Re: Roberts Gap Project, #53597

The Ozark Society, representing 1,000 members would like to make the following comments about the Roberts Gap Project. Please include them in the record. Thank you for the opportunity to make these recommendations.

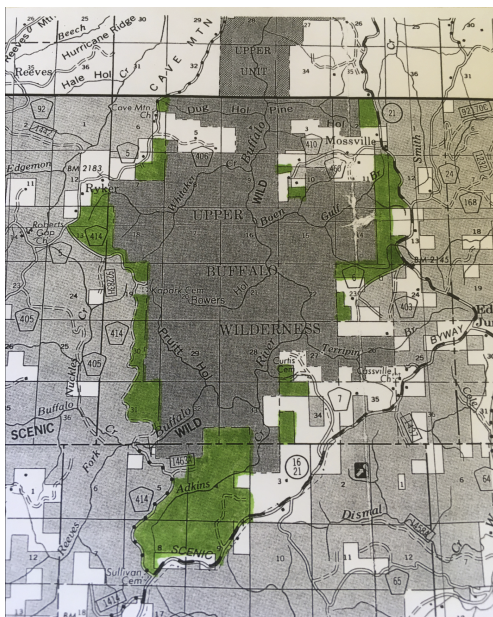
There are approximately 3000 acres (all Forest Service land) in several tracts, that have been identified as having the potential to be considered for wilderness designation as additions to the existing Upper Buffalo Wilderness Area at some point in the future. As potential wilderness, it is important that these lands be protected now so they will better retain their natural characteristics over time so they can later be considered for wilderness. The map below shows these potential additions marked in green.

Our recommendation is that the Forest Service not plan any new road building, timber, or forest and wildlife management activities in the lands.

Alternative 3 does show management activities planned for portions of the green area marked on the map for protection. The following is a list of compartments and activities

Comp. 56, Hardwood Thinning; Comp. 57, Pine Thinning; Comp. 58, Hardwood Shelterwood; Comp. 166, Hardwood Thinning; Comp. 161, Hardwood Thinning; Comp. 159, Hardwood Shelterwood (the portion north and east of Road 414); Comp. 158, Pine Thinning; Comp.157, Hardwood Thinning; Comp. 86, Hardwood Thinning (the portion east of Road 414); Comp. 85, Hardwood Thinning; Comp. 84, Hardwood Thinning (the portion east of Road 414); Comp. 83, Pine Thinning (the portion east of Road 414); Comp. 79, TSI; Comp. 70, Hardwood Thinning; Comp. 71, Hardwood Shelterwood; Comp. 72, Pine Thinning (the portion on the east side of Dixon Ford Road); Comp. 78, Pine Thinning (the portion on the east side of Dixon Ford

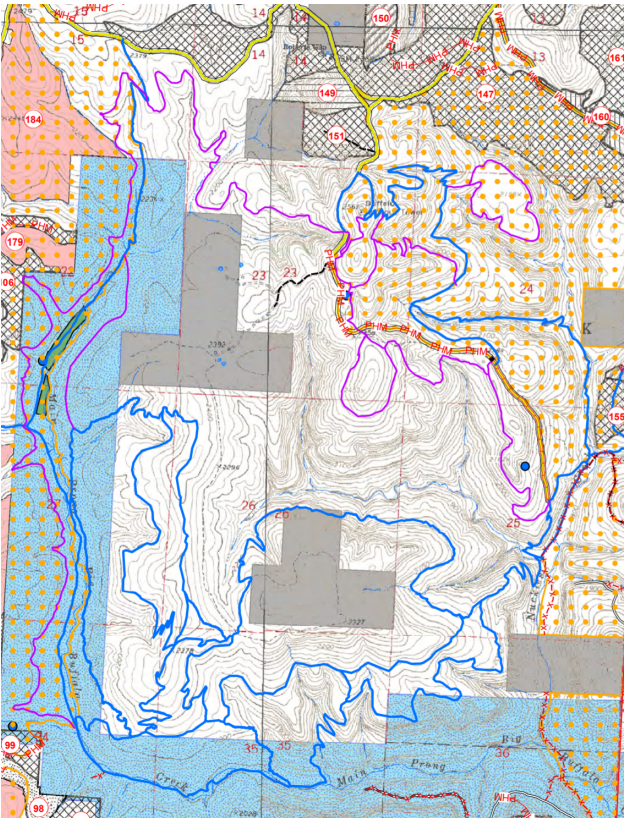
Though we would prefer to not have any additional trails here, we understand that a connector trail or two, bringing together the main parts of the existing bike trail system, would be desirable for many bikers, and would not significantly expand the overall footprint of the existing trail system. However, some of the other proposed trails, shown on the Alternative 3 Map, do expand into undeveloped wild places, and we recommend that these proposed trails be removed from the plan. Please consider the following proposed trails (in Alternative 3) for removal from the plan.

- 1) The proposed trail (marked in purple) starts by branching off the existing trail system, about a quarter mile south of the Cave Mountain Road Trailhead. It runs south along the west side of the Main Prong of Big Buffalo Creek for about 4 miles where it joins the existing trail system near the middle of Section 34.

- 2) The proposed trail (marked in purple) that extends beyond the northeast corner of the existing trail system to the northeast and forms a loop around a mountain top, which shows an elevation on the map of 2158.

- 3) The proposed trail (marked in purple) that extends south from the Buffalo Lookout Tower and forms a loop around a mountain top about a half mile due south of the Buffalo Lookout Tower, then extends south another quarter mile and forms another loop around a mountain top, with an elevation marked on the map of 2453. The trail continues to the east and southeast for another one and a half or two miles and joins the existing trail system within a quarter mile of Knuckles Creek, near the middle of Section 25.

Proposed areas to protect for possible future wilderness in green

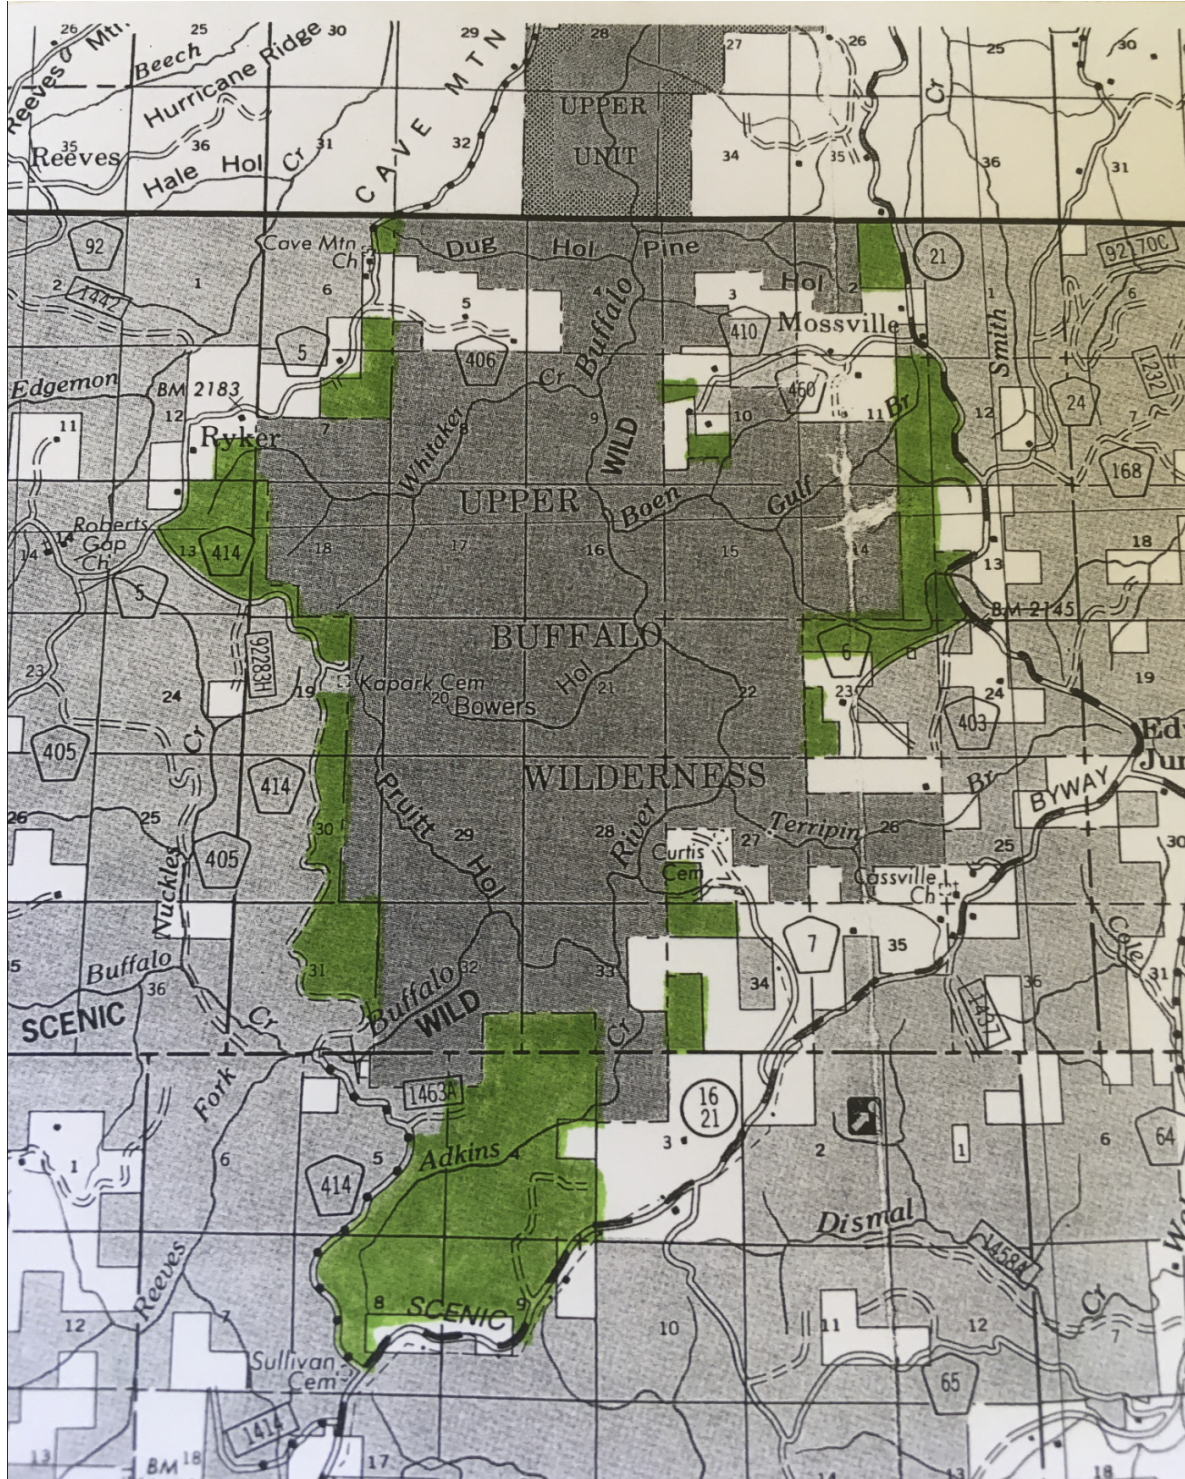
Alternative 3 has proposed timber management activities on some of lands that have potential as wilderness additions to the Upper Buffalo Wilderness. We recommend that no timber activities be done on these 3000 acres of potential wilderness lands, which are marked in green on the attached map.

Alternative 3 has proposed some timber management activities in the Edgemon Creek Watershed in an area that we have proposed for protection. These lands are marked in orange on an attached map. We recommend no timber activities be done in this area marked in orange on the attached map.

The area that we are recommending for protection is approximately 1120 acres in size. Much of this acreage is too steep and rugged to be practical for timber management. Protecting this area, shown on the attached map in orange marker, will require a change in Alternative 3 to not do any timber activities, road building activities, or wildlife activities in the area. Protection of this 1120 acres, will affect timber-related activities to different degrees in Compartments 37, 44, 45, 46, 47, 51, 52, 53, 54, 55, but most of timber management activities proposed in the Edgemon Creek watershed in Alternative 3, will not be affected by this 1120-acre protected area proposal.
